UNITED STATES PATENT AND TRADEMARK OFFICE

Office Action Summary

10/604,078

DETAILED ACTION

Figure 2

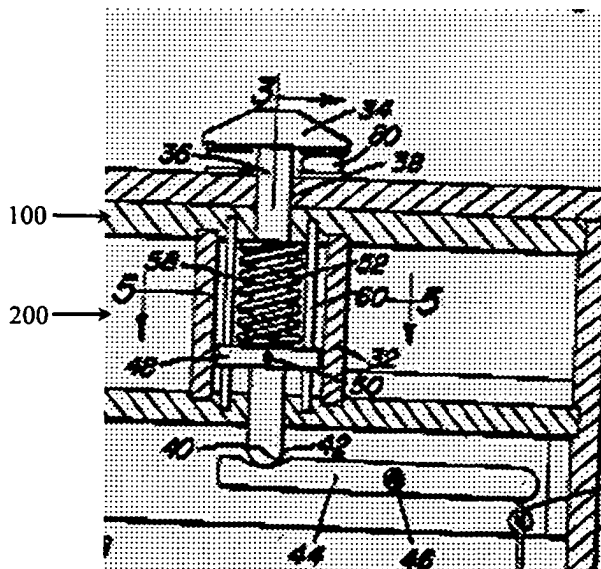
Claims 1-6 are rejected under 35 U.S.C. 102(b) as being anticipated by Prescott (U.S.

Patent 2,712,769) (see marked-up drawing below).

Claim 1. Prescott discloses (fig.2) an apparatus for clamping a reference surface (surface of 24 contacting 100) of an object (80, 24) to a reference surface (surface of 100 contacting 24) of a support member (100), comprising: at least one clamping member (200 of the marked-up figure above denotes a clamping member in as much as 100 of the applicant's drawings does) having means (52) for applying compressive force between a first contact surface (surface of 52 contacting 100) and a second contact surface (surface of 34 contacting 80), said first contact surface being in contact with a support surface (surface of 100 contacting 52) of said support member, said support surface of said support member being opposite said reference surface of said support member, each of said clamping members having a base member (34) with a contact area (area of 34 contacting 80) in contact with a support surface (surface of 80 contacting 34) of said object (80, 24), said support surface of said object being opposite said reference surface of said object, each of said clamping members having a tension member (36) passing through holes (hole in 100, hole in 24) in said support member and said object for applying a force to said base member and for supporting said object when said force is released, said tension member being adapted to maintain a tensile force (within itself between 48 and 34) and having a cross section adapted such that said tension member exerts transverse force (force applied to 80 is in a transverse direction with respect to 24) on said object less than a threshold amount (some amount greater than that supplied by 52, which might damage 80) in response to transverse displacements of said clamping member such that the deviation from an adjusted position is within a relevant error budget (any relevant error budget).

Claim 2. Prescott discloses that the means for applying compressive force is a spring (52) and said first contact surface is a surface of said spring.

Claim 3. Prescott discloses release means (44) for releasing compressive force.

Claim 4. Prescott discloses that the release means comprises a lever pressing (indirectly via 36 and 48) against the means for applying compressive force. Note that the lever (20) of the applicant's invention does not directly contact the spring (120).

Claims 5 and 6. Prescott discloses that support means (portion of 100 contacting 24) support the object when the compressive force is released.
